**Addendum No. 002**

**Subject: 2020 Classroom Modernizations**  
**SDP Contract Numbers: B-007 C of 19/20 & B-009 C of 19/20**

**Location: George Sharswood School**  
**2300 S. 2nd St, Philadelphia PA 19148**

**This Addendum, dated February 27, 2020, shall modify and become part of the Contract Documents for the work of this project. Any items not mentioned herein, or affected by, shall be performed strictly in accordance with the original documents.**

1 ELECTRICAL SECOND FLOOR POWER PLAN  
E2.2 1/8" = 1'-0"

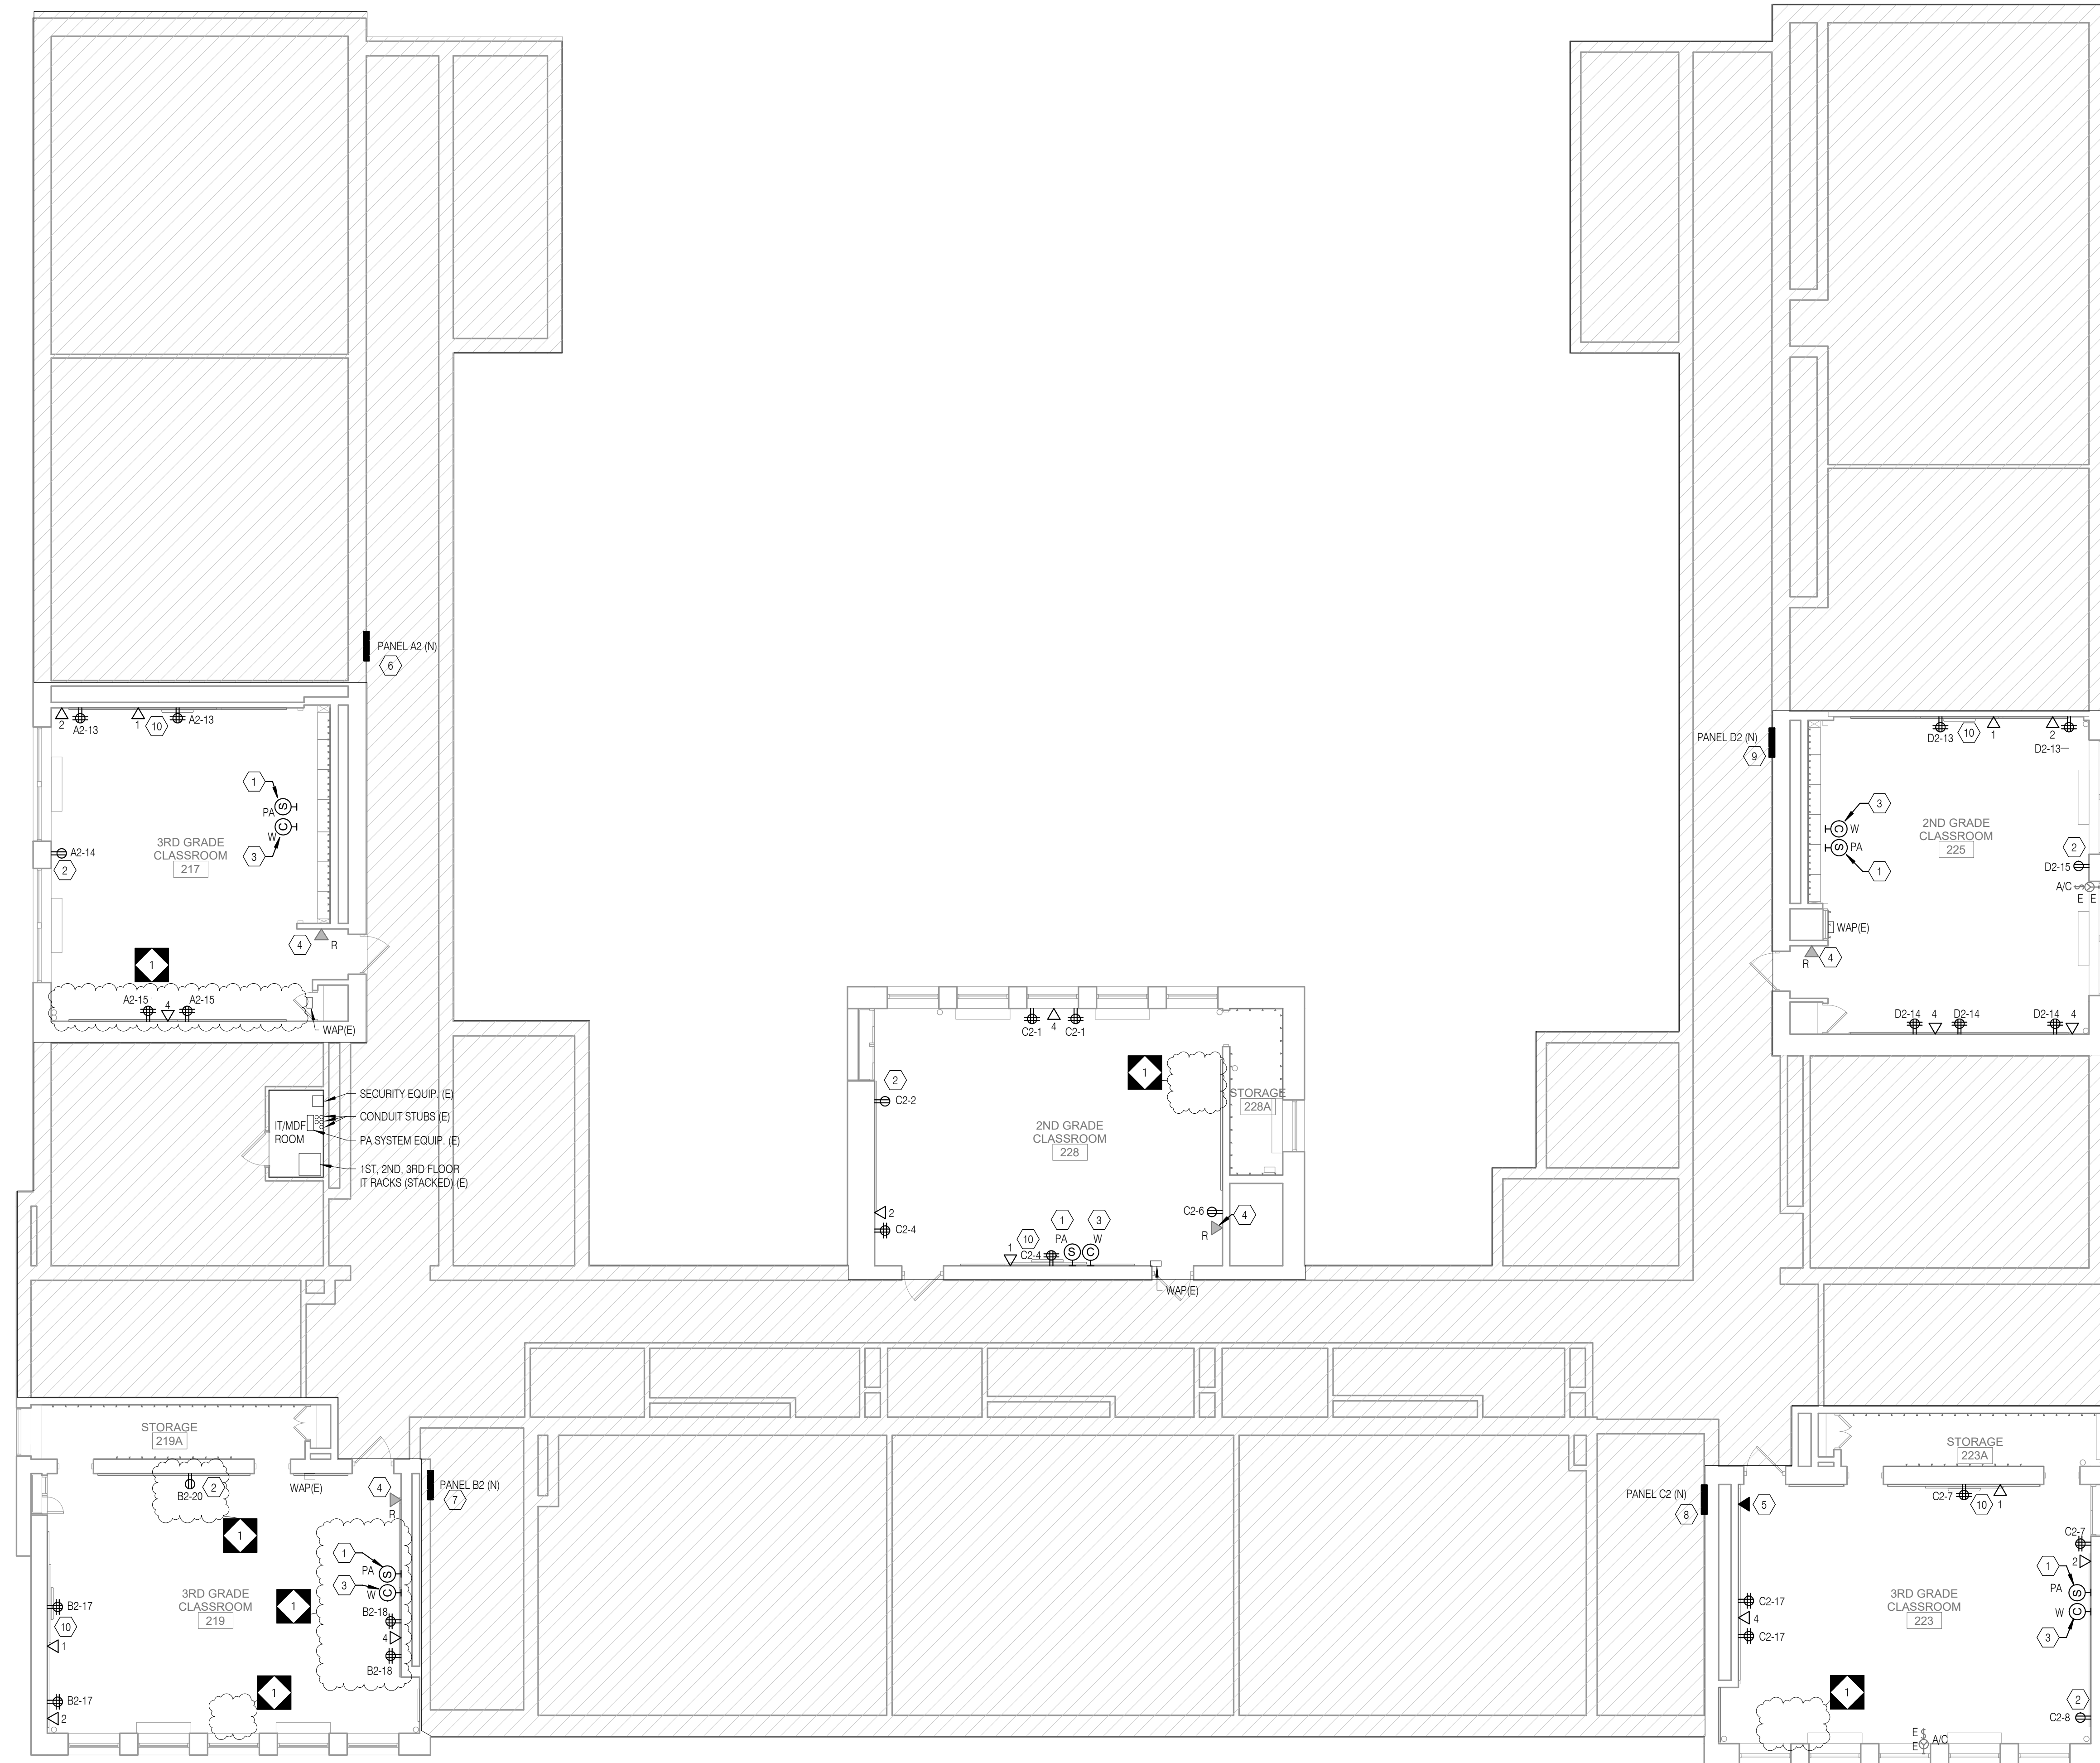
1. ADD General Sheet Note #6 to read "ELECTRICAL CONTRACTOR TO RUN ALL NEW SURFACE MOUNTED CONDUITS AND RACEWAYS IN CORNERS OF EACH CLASSROOM TO AVOID CONFLICT WITH DISPLAY BOARDS AND OTHER CLASSROOM FURNISHINGS."
2. REVISE power and data layout as indicated on the drawings.
